## VEIC RESPONSES TO VSPC PARTICIPANT QUESTIONS

### VEIC Responses to GMP's Questions

1/24/2011

**Treatment of savings decay**

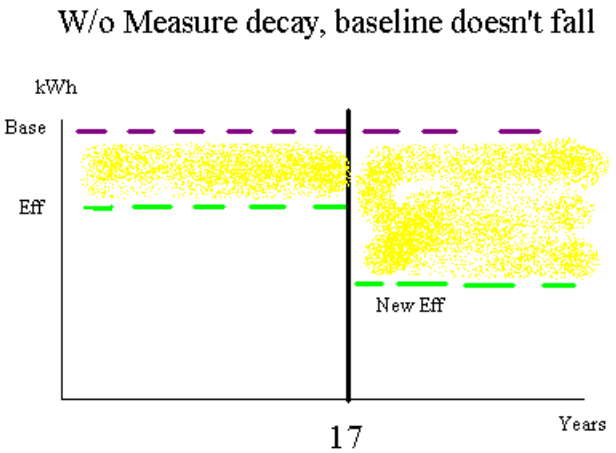
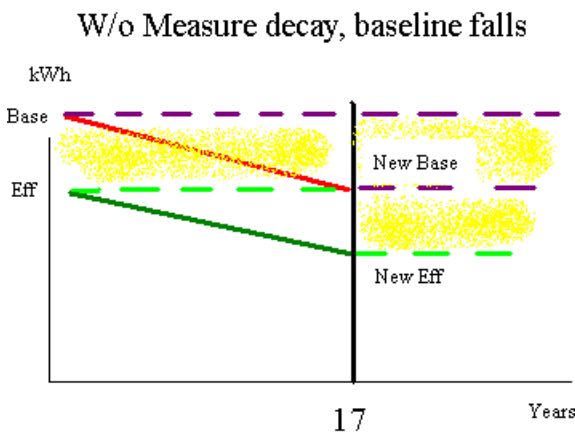
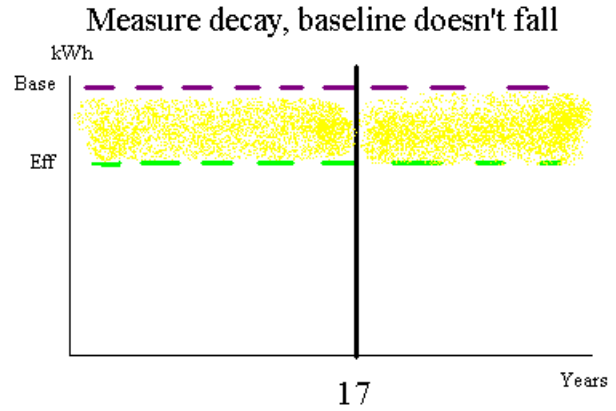
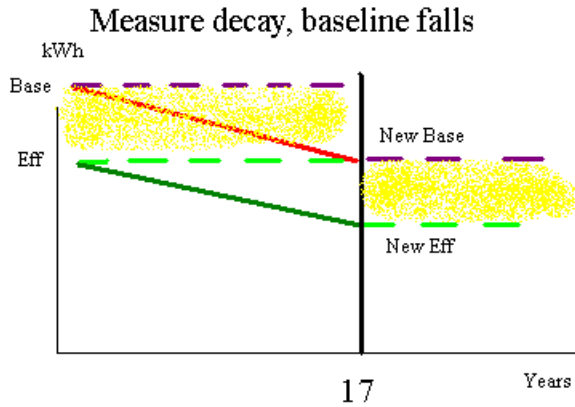
The data in the table below are from slides 26 and 27 of the VEIC presentation. Between 2020 and 2031, the residential “Cumulative Savings (w/decay)” increases by about 362,591 MWh and over the same period there were a total of 1,375,455 MWh in incremental efficiency savings added. This would suggest a significant amount of decay is happening in the second half of the forecast, and this is after the significant lighting standards adjustment. Aside from lighting programs (which have shorter lifetimes), should we really expect to see that much decay in the last ten years of the efficiency forecast?

Shouldn't we expect that the 3,600 kWh savings from a EWH fuel switch will not come back on the grid when the new water heater reaches the end of its life after 13 years? And for many other measures (refrigeration, window replacement, etc.), wouldn't you assume that most of the efficiency savings do not “reverse” back onto the grid either? If we allow the savings to decay, aren't we saying that the customer who participates in a refrigerator program will replace their refrigerator 17 years later with one that is at the baseline efficiency level from 17

years early if they are not given any incentives? Or would the customer install a refrigerator that is at least as efficient as the one they had, even without incentives?

VEIC Response: Yes. In a maximum achievable forecast, one installs the maximum amount of cost-effective efficiency as early in the forecast period as possible. This results in the modeling of the retrofit of all refrigeration and other measures that have long and short measure lives in the first 10 years of the forecast period. As these measures reach the end of their effective useful lives, the savings decay. For example, VEIC models a suite of measures and increases their penetrations to 90% of the available market within the first 5 years of the analysis period, and then holds that penetration rate constant at 90% for the remaining period. If we assume that all measures have a measure life of 10 year, then, for the first ten years, each year you are adding 90% of the available new/replacement market savings. In the 11th year you add another 90% of the available market savings (for purchases that year), but the savings you added in year 1 are now over (measure decay). That is, those measures have come to the end of their life and their replacements are now part of the new 90% penetrations for the 11th year. The “new” savings would almost match the retired savings and so the cumulative savings would be pretty much constant from then on. There are a few measures that we don't model as having significant penetration until the later years, but for the majority of measures, we are ramping up penetrations pretty quickly.

VEIC Response: Savings or measure decay should be accounted for in the baseline forecast. The baseline forecast includes modeling of naturally occurring efficiency or efficiency that results from improved technology, codes and standards. That is, the baseline improvement in efficiency should capture or model the EWH fuel switch “not returning” to the grid.

Imagine the purchase of a refrigerator and the associated consumption in each scenario pictured below. If you have measure decay you end up saving (yellow) a constant amount over the years whether or not the baseline forecast predicts a fall in consumption. Without quantifying measure decay, you end up double counting savings. You count the savings from the first purchase (that don't decay), PLUS savings from the second after 17 years.
